# Clearwater Specific Plan Environmental Impact Report

# FINAL ENVIRONMENTAL IMPACT REPORT THE CLEARWATER SPECIFIC PLAN

SCH NO. 2006062154

Subject: Response to Comments: Mammoth Clearwater Revised Site Plan

REVISED FIGURE 12

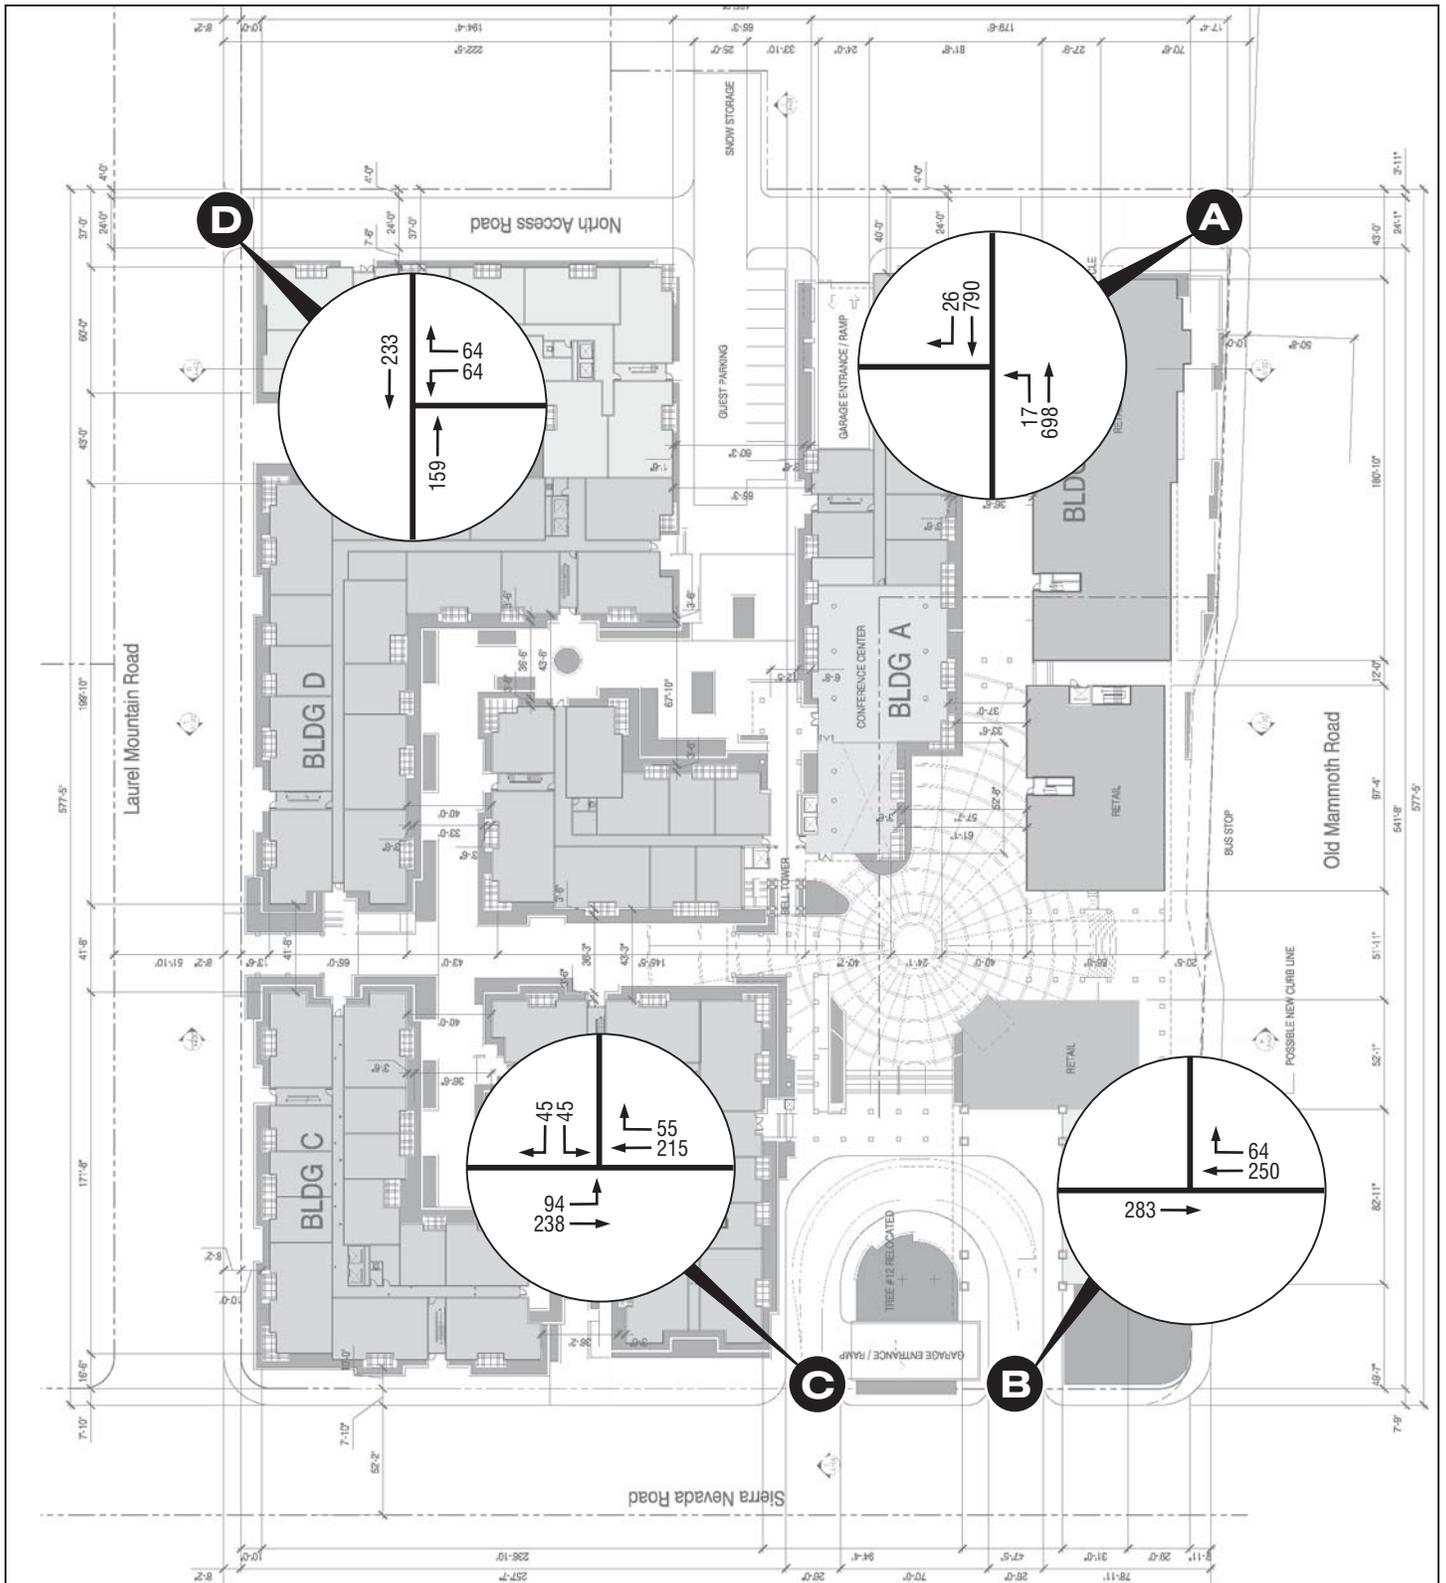
LSA reanalyzed the project driveways as a result of changes to the site plan. The entrance to the porte-cochere has been moved from Old Mammoth Road to Sierra Nevada Road, approximately 79 feet from the westerly curb of Old Mammoth Road. Additionally, the exit of the porte-cochere has been combined with the southern entrance/exit of the parking garage and is located approximately 175 feet from Old Mammoth Road. The change in access alters volume at each project driveway. Visitors to the commercial uses of Mammoth Clearwater are assumed to primarily use the southern entrance of the parking garage, whereas hotel and workforce housing residents will find some utility in the northern garage entrance. Revised volumes are presented in a revised Figure 12 attached to this letter.

**SIGHT DISTANCE PHOTOGRAPHS**

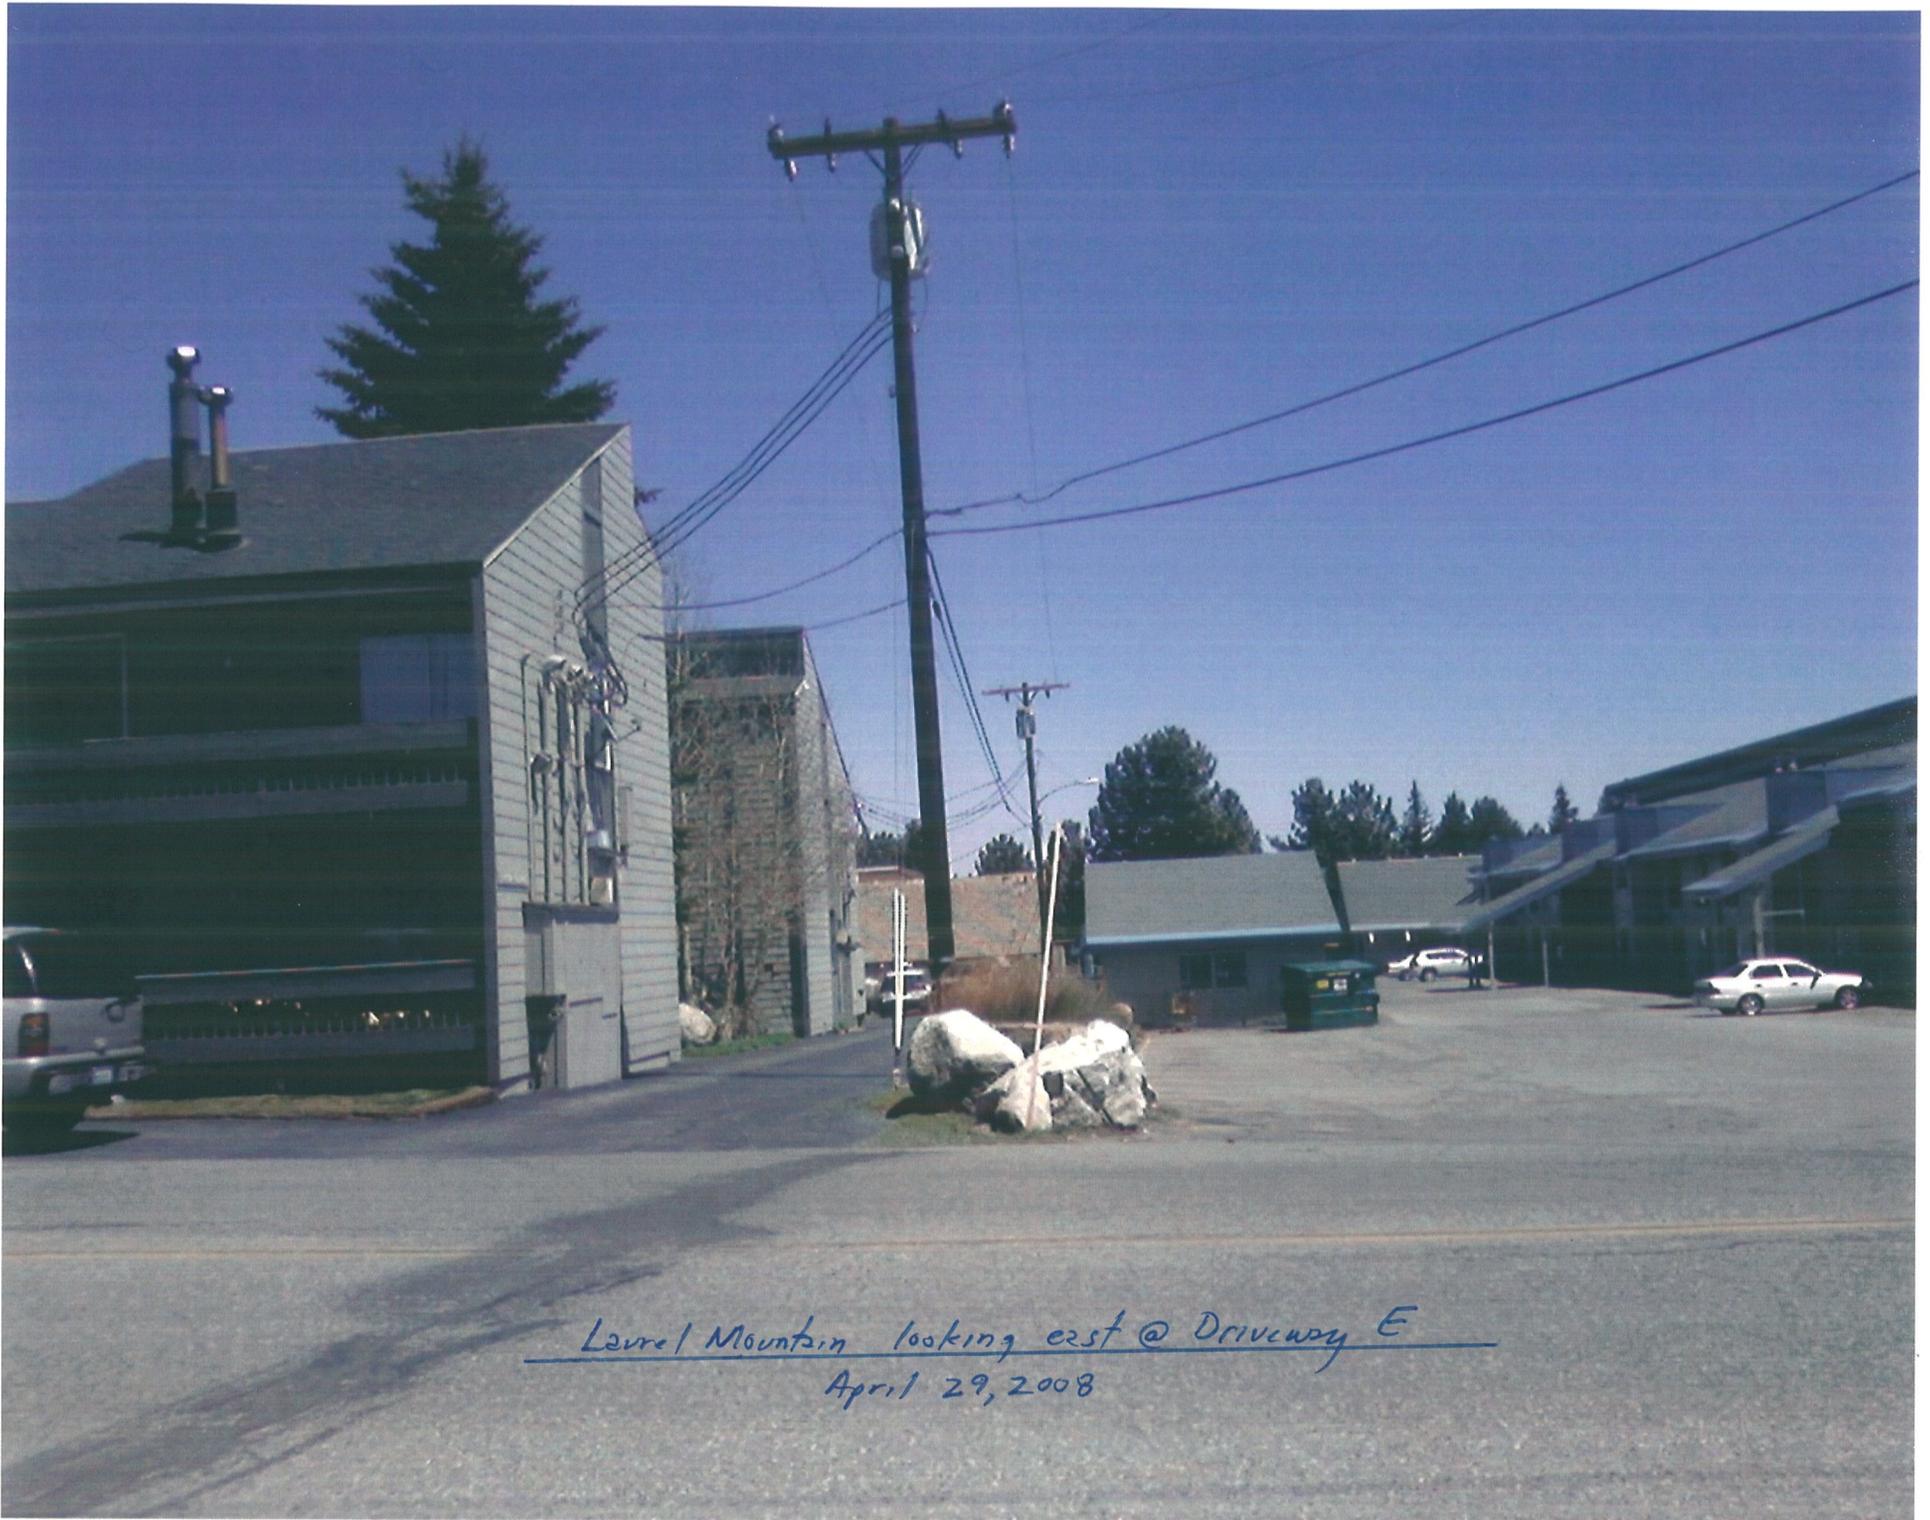
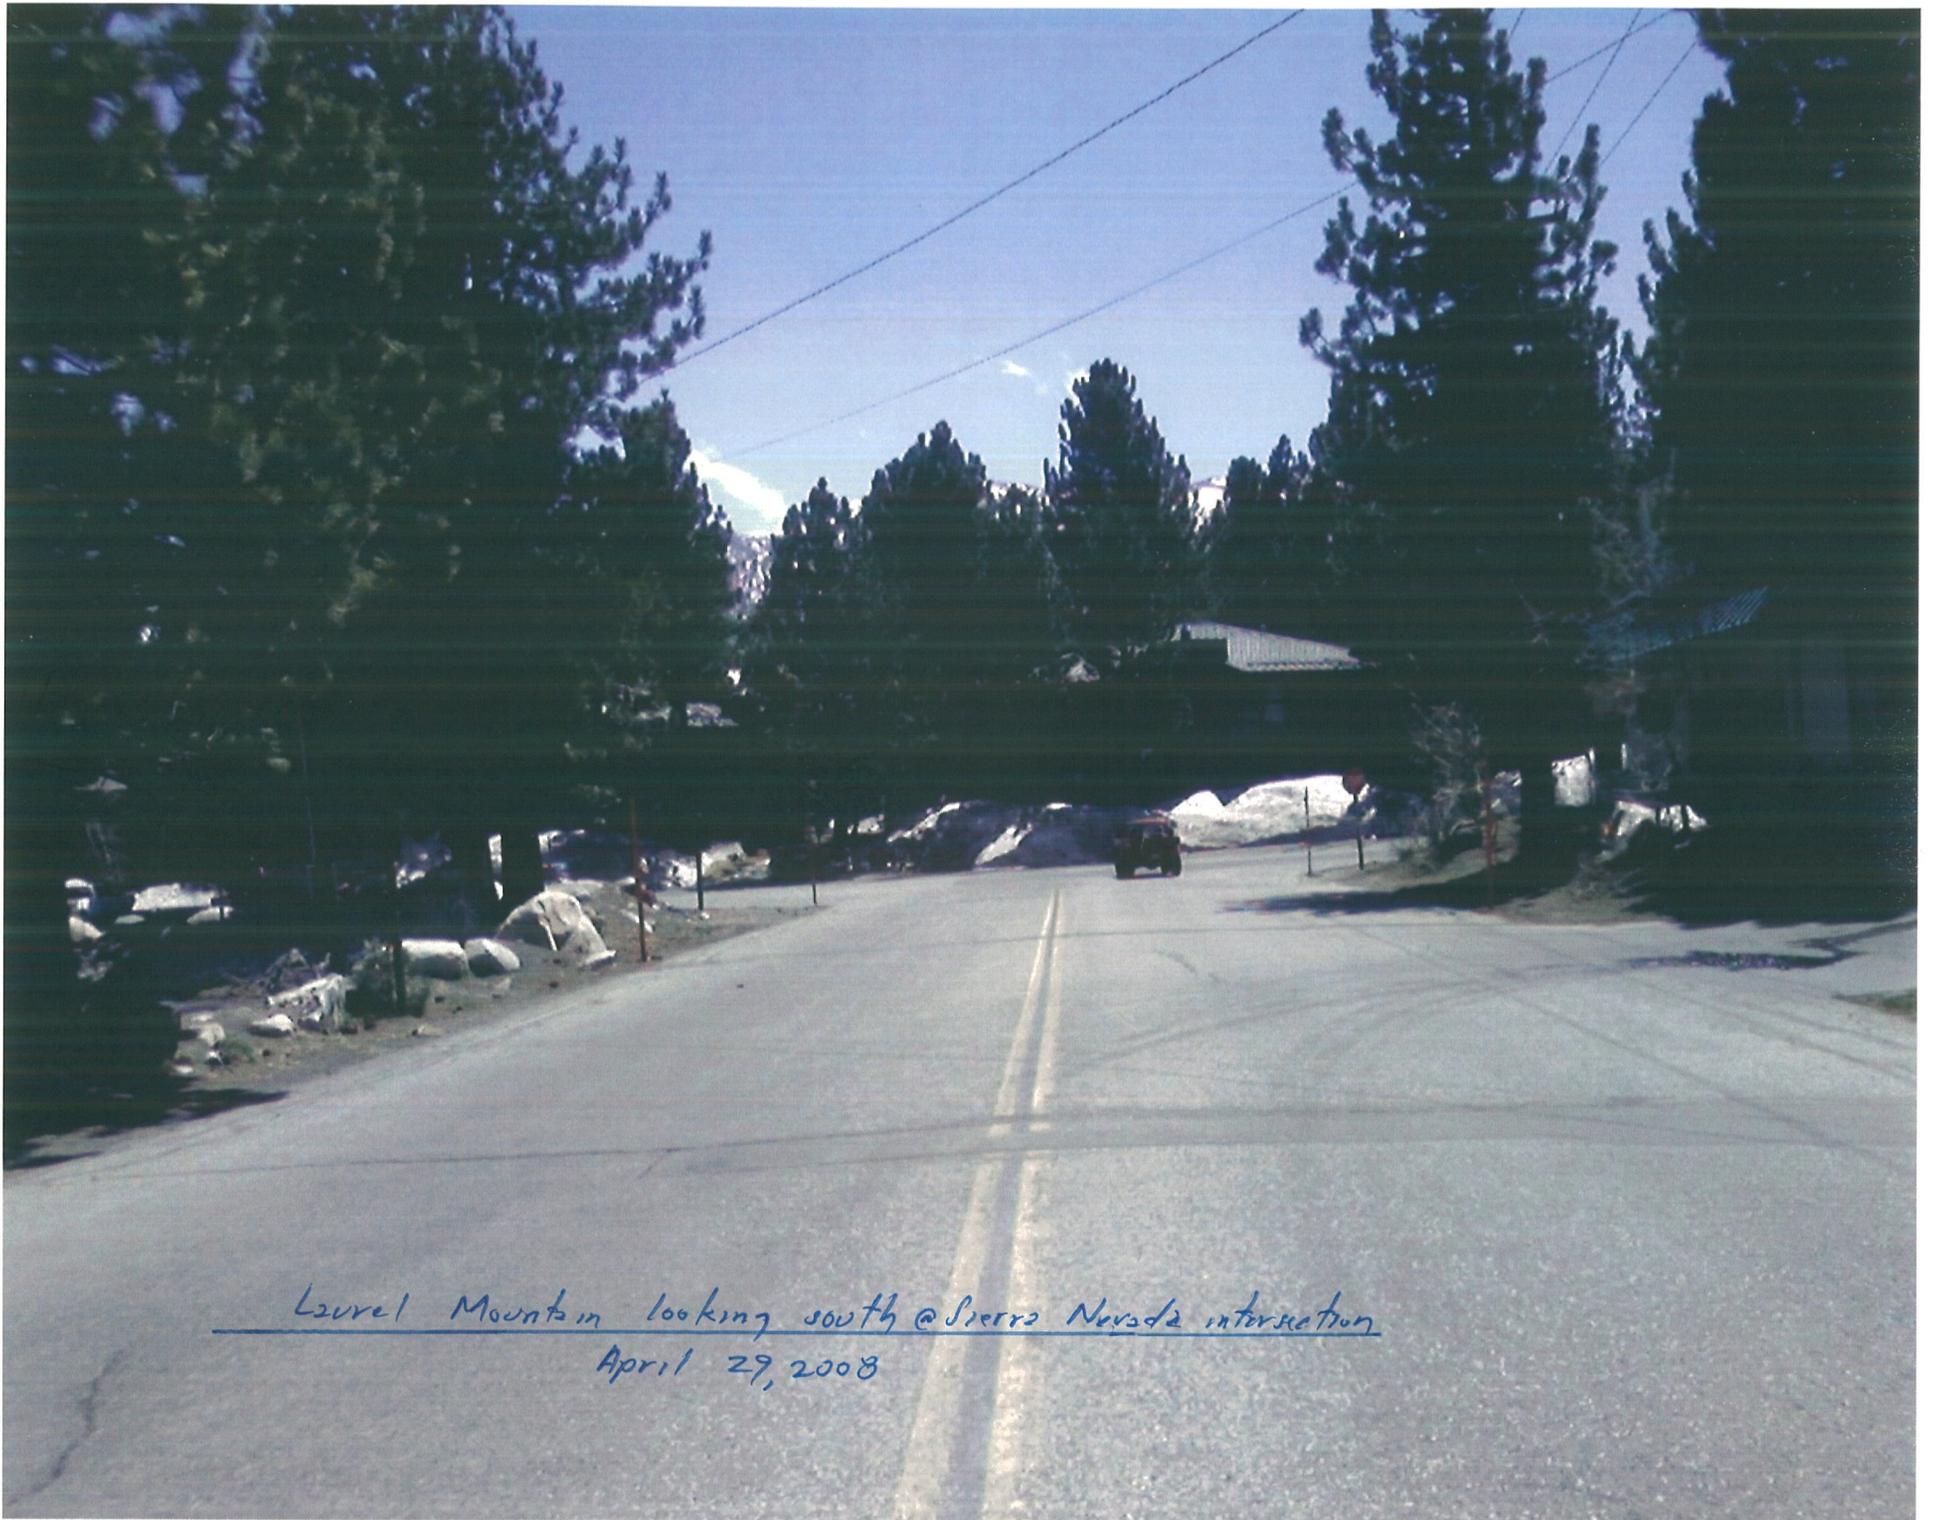
**COMMENT 4**

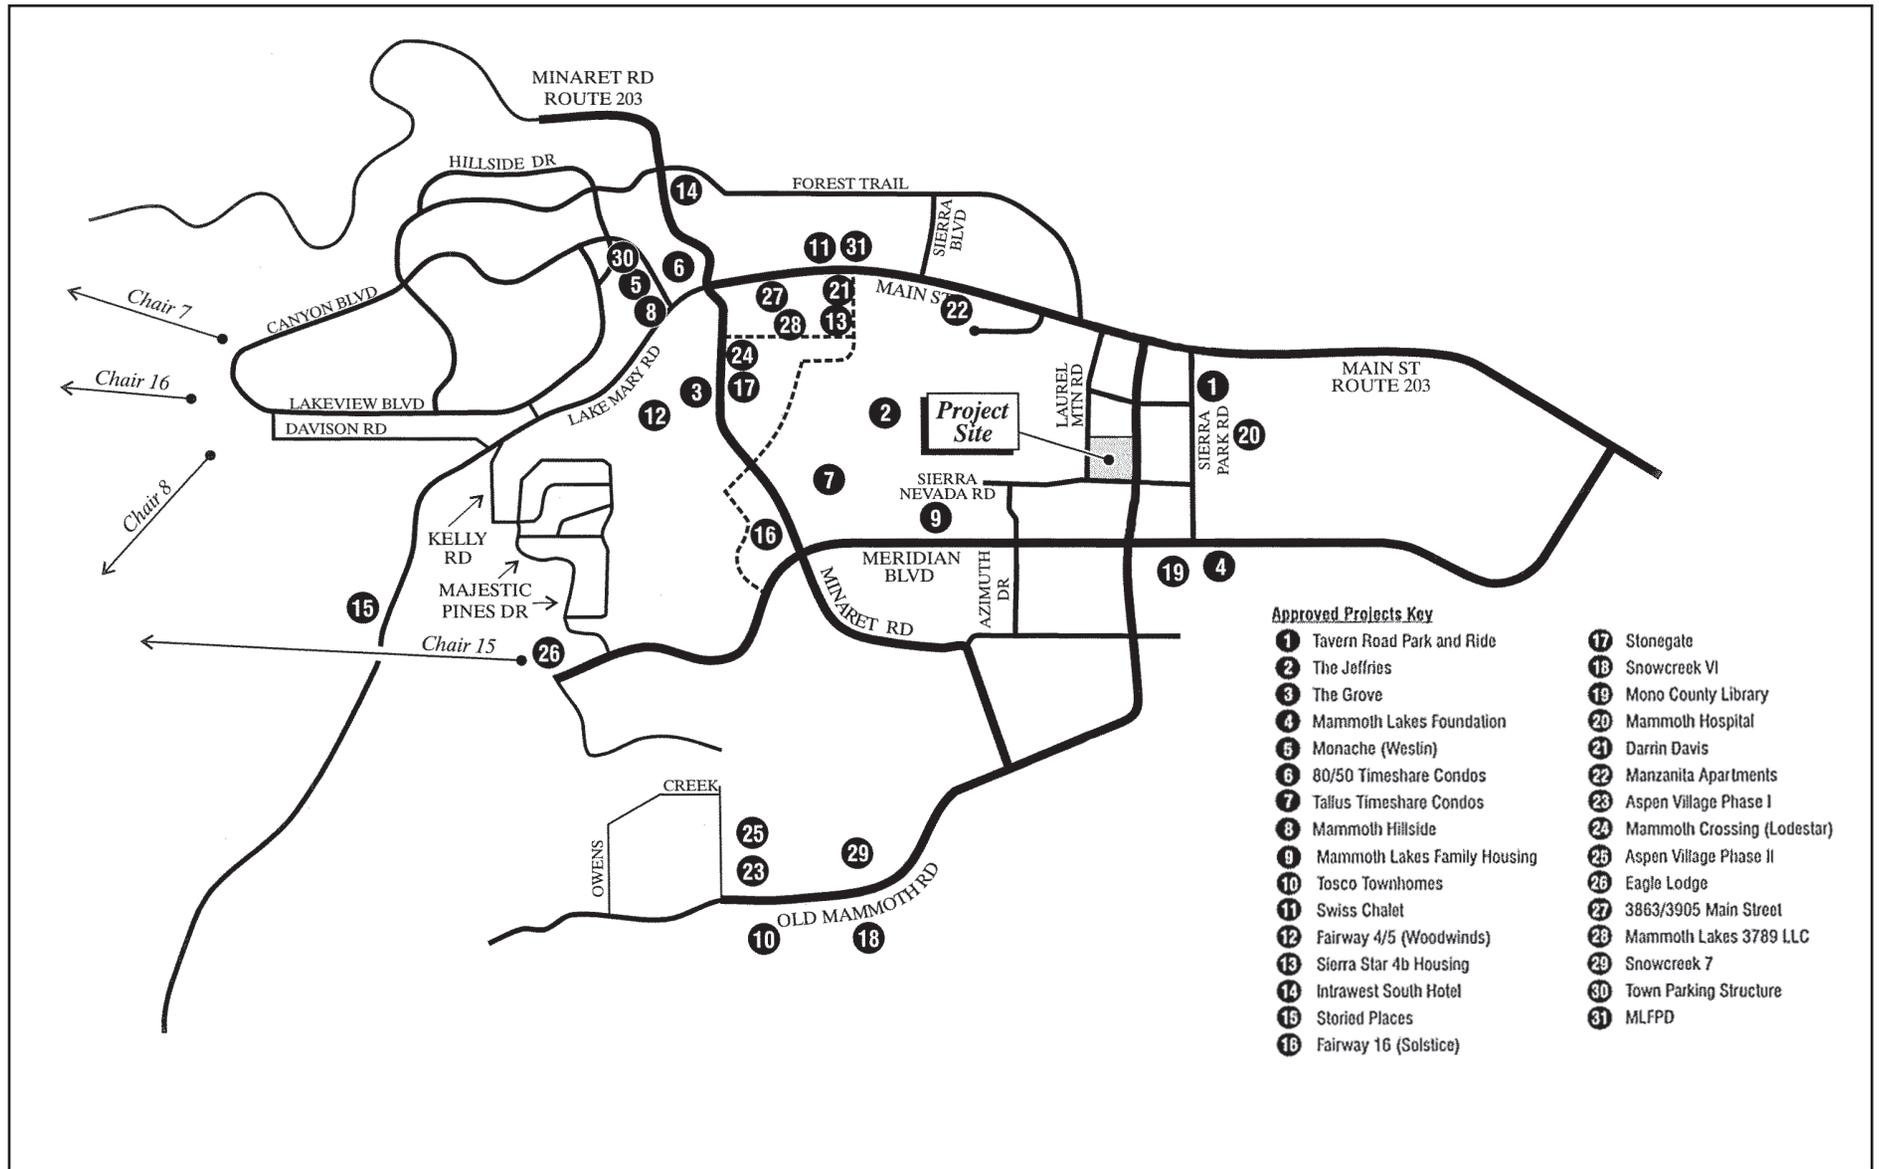
Please refer to the revised Exhibit 5.3-4, *Clearwater Trip Distribution*, for a clarification on trip distribution patterns.
